Technical Service Bulletin: TSB220176**Released Date: 23-Aug-2022****Safety Campaign #4935 C500D6RE Door Switch Logic Corrective Action**

Safety Campaign #4935 C500D6RE Door Switch Logic Corrective Action

- C500D6RE

Figure 3: Mounting of DIN Rail and Relays

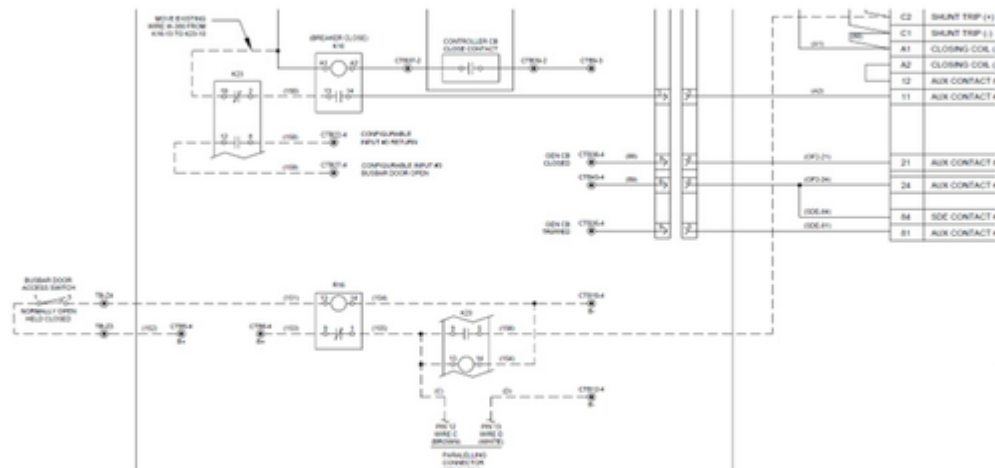
4. Place end stop, 3 pole relay (K23), 1 pole relay (R16) onto the Din rail. (See Figure 3)

Figure 4: : Cummins Control Panel Wiring Diagram

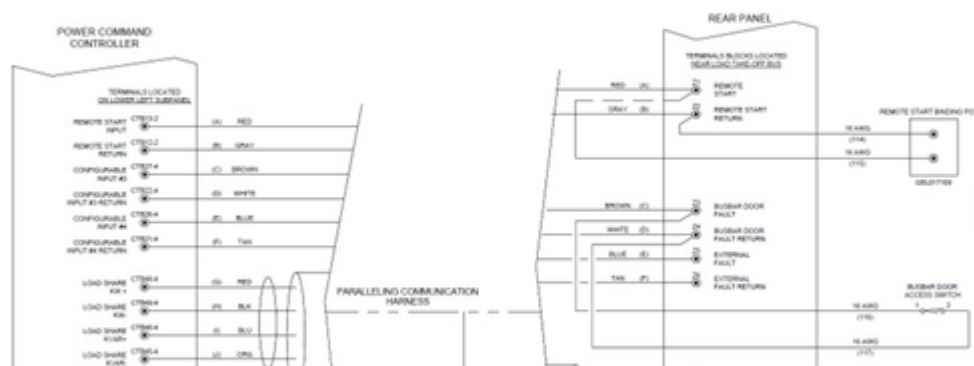
- Some C500D6RE rental generator sets have incorrect door switch logic, disabling the generator set's shut down command to paralleled generator sets when the busbar door is opened during paralleled operation of the generator set, potentially exposing the operator to energized electrical components.

- Incorrect busbar door switch wiring.

5. Inside of the power command controller box, remove wire W-386 from K16-13 and move it to K23-10 (see Figure 4).
6. Remove Wire "C" (Brown) from CTB27-4 and move it to K23-13. Wire should now connect the paralleling connector to K23-13 (see Figure 4 and Figure 5).
7. Remove wire "D" (white) from CTB22-4 and move it to CTB12-4. Wire should now connect the paralleling connector to CTB12-4 (see Figure 4 and Figure 5).
8. At the rear customer connection panel, remove the customer connection cover panel and remove wire "C" (Brown) from TB-Z3 and move it to TB-Z14 (see Figure 5).
9. Remove wire "D" (white) from TB-Z4 and move it to TB-Z15 (see Figure 5).
10. On the busbar door switch, remove the wire from pin 2 (normally closed) and move it to pin 3 (normally open) (see Figure 4 and Figure 5).

11. Wire from K23-2 to K16-13 (see wire 150 in Figure 4).
12. Wire from R-13 to TB-Z4 (see wire 151 in Figure 4).

13. Wire from CTB5-4 to TB-Z3 (see wire 152 in Figure 4).

14. Wire from CTB6-4 to R16-9 (see wire 153 in Figure 4).

15. Wire from CTB10-4 to R16-14 and jumper from R16-14 to K23-14 (see wire 154 in Figure 4).

16. Wire from R16-1 to K23-9 with jumper from K23-9 to K23-13 (double K23-13 with wire "C" and (155) (see wire 155 in Figure 4).

17. Wire from K23-5 to 52G-C2 (see wire 156 in Figure 4).

18. Wire from CTB22-4 to K23-8 (see wire 158 in Figure 4).

19. Wire from CTB27-4 to K23-12 (see wire 159 in Figure 4).
